Service bulletin

C. 251

DISC BRAKES

Healey
Sprite
MK. IIA

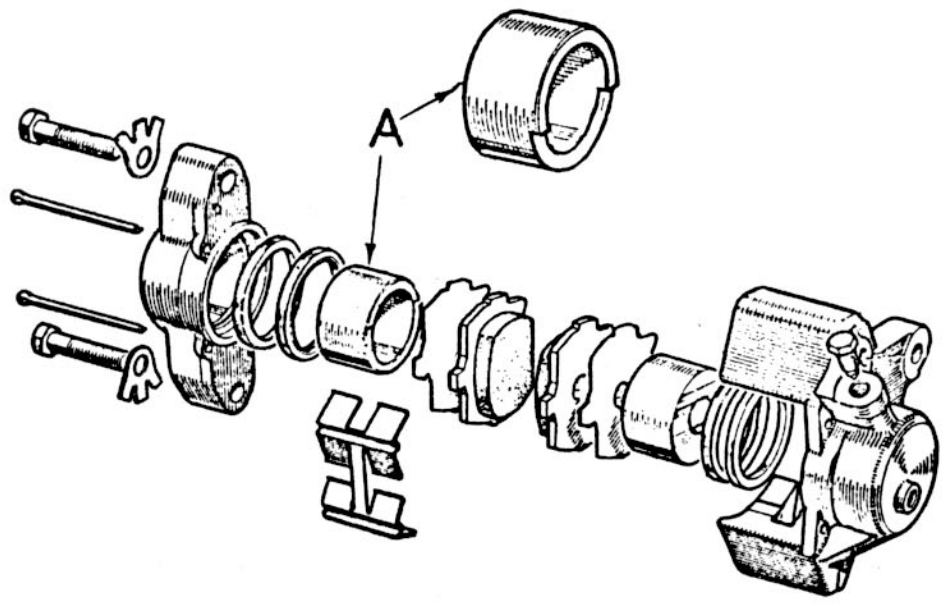
When refitting disc brake pistons to the caliper housing, care should be taken to see that the cutaway part of the piston faces downwards as shown at 'A' (left hand caliper drawn.)
